## **Technical Bulletin / Safety Alert**

**Unique ID No:** GEN2010-TBSA-04

**Subject:** JUG-A-0 UL/UV Exhaust Conditioner Makeup Tank Exhaust Check Valve

**Applicable to:** All JUG-A-0 UL/UV machines.

**Figure 1:** Photographs showing quick exhaust valve Part No. 0601-60007, and as installed.

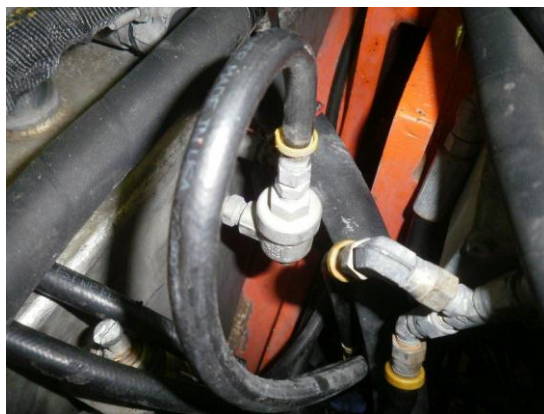
The exhaust check valve (0601-60007) is shown in Figure 1 for reference.

**Figure 3:** Recommended Pneumatic Circuit installation of exhaust check valve (Item No. 85, Part No. 0601-60007) and new check valve (Item No. 111, Part No. 0601-10027).

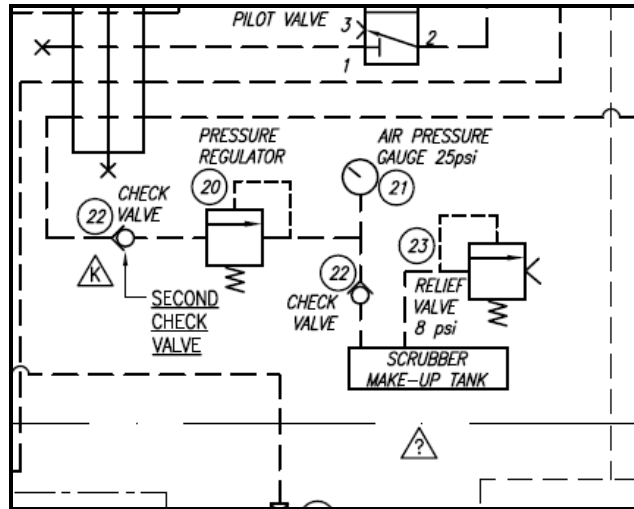
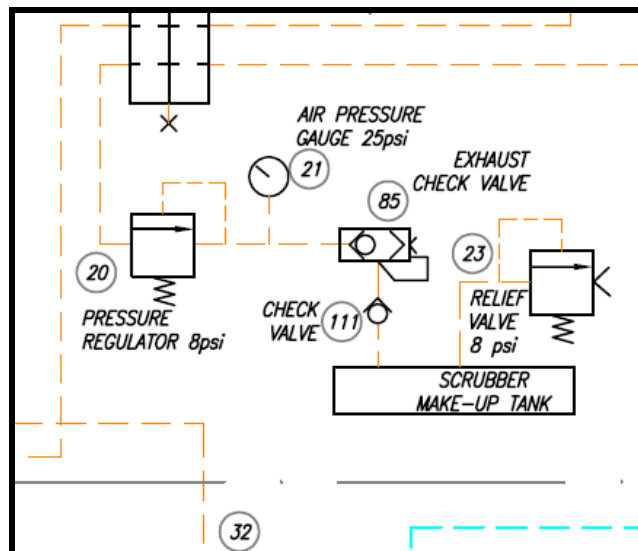
Previously (refer GEN2010-TBSA-04 Rev 1), the existing check valves (2 off part no. 0601-10022) installed in the air line between the manifold and the exhaust conditioner

water makeup tank were recommended to be replaced with an exhaust check valve (part no. 0601-60007) to improve air line serviceability.

Subsequently it was discovered that the absence of check valves at this position resulted in release of air system pressure from the main air circuit each time the machine was shut down, and in some instances insufficient air pressure remained in the circuit to enable the machine to be restarted. To counter this unintended outcome, a new stainless steel check valve (0601-10027) is recommended to be installed with the exhaust check valve to maintain air circuit pressure at shutdown. The exhaust valve continues to provide secondary protection to the main air circuit from moisture ingress, at the same time as providing self-evident fault indication in the event that the check valve fails, since air system pressure will be lost.

The original pneumatic circuit is shown schematically in Figure 2 and the current recommended pneumatic schematic installation is shown at Figure 3.

Replacement of the two (2) check valves, described above, with a single stainless steel check valve and quick exhaust valve reduces the risk of valve deterioration and failure due to moisture exposure, and improves protection of the shutdown circuit from moisture ingress.

It is recommended the described circuit changes be implemented at the next major service interval.
